ADDENDUM # 2

RFQ 19C5, Security Vestibules for Monocacy Middle, Ballenger Creek Middle and Catoclin High Schools

ADDENDUM NO. 2

MONOCACY MIDDLE SCHOOL – Frederick, Maryland
BALLENGER CREEK MIDDLE SCHOOL – Frederick, Maryland
CATOCTIN HIGH SCHOOL – Thurmont, Maryland

**BALLENGER
CREEK
MIDDLE
SCHOOL**

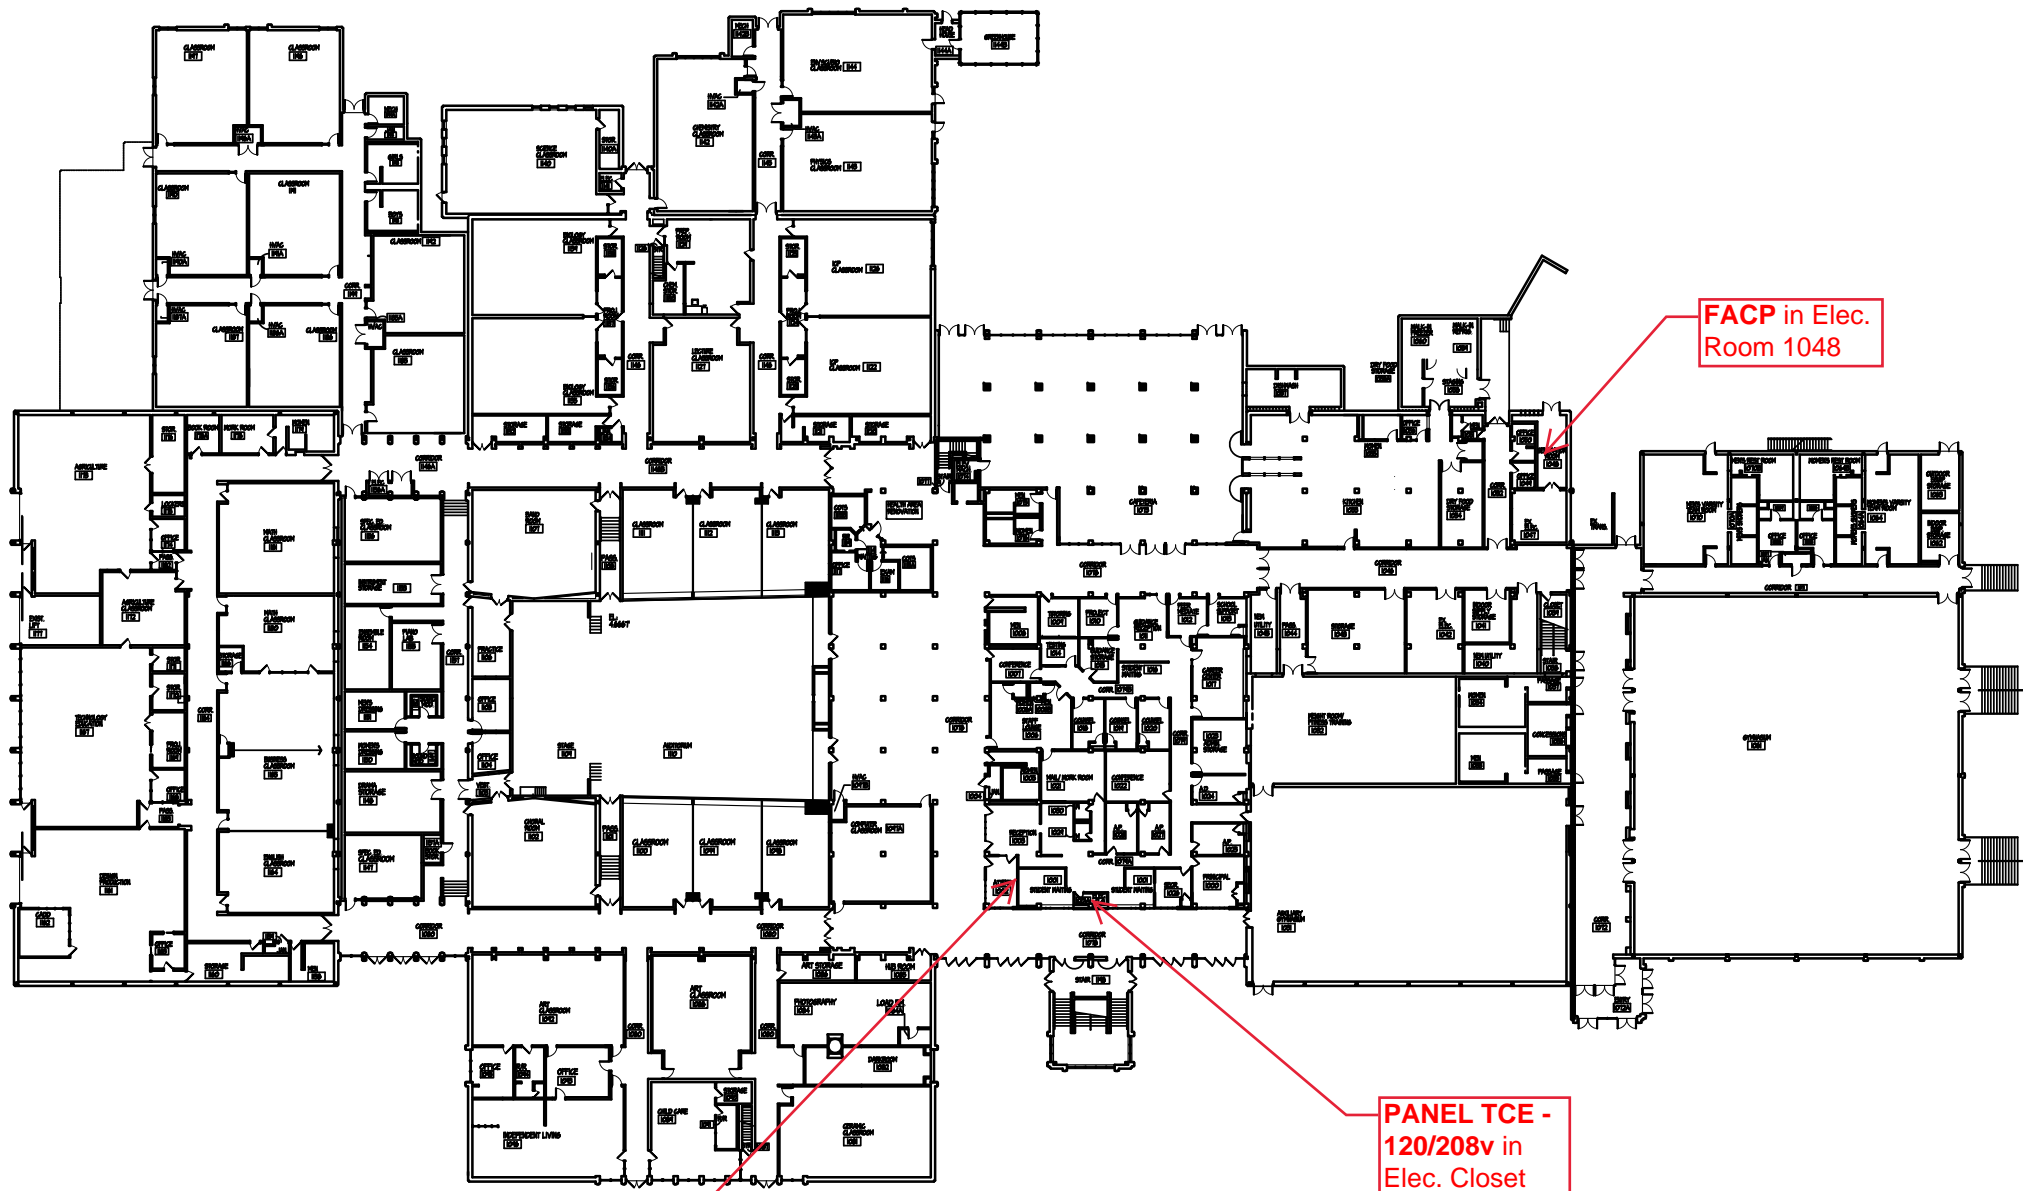
**PANEL #24 - 120/208v
with spaces in Elec. Closet**

Ballenger Creek

- 120V power shall be installed from existing panel "#24" with location shown on the attached. Provide a single pole 20A breaker in space #16 (panel by GE) and 2 #12 & 1 #12 EGC in ¾" C
- No other additional power is required
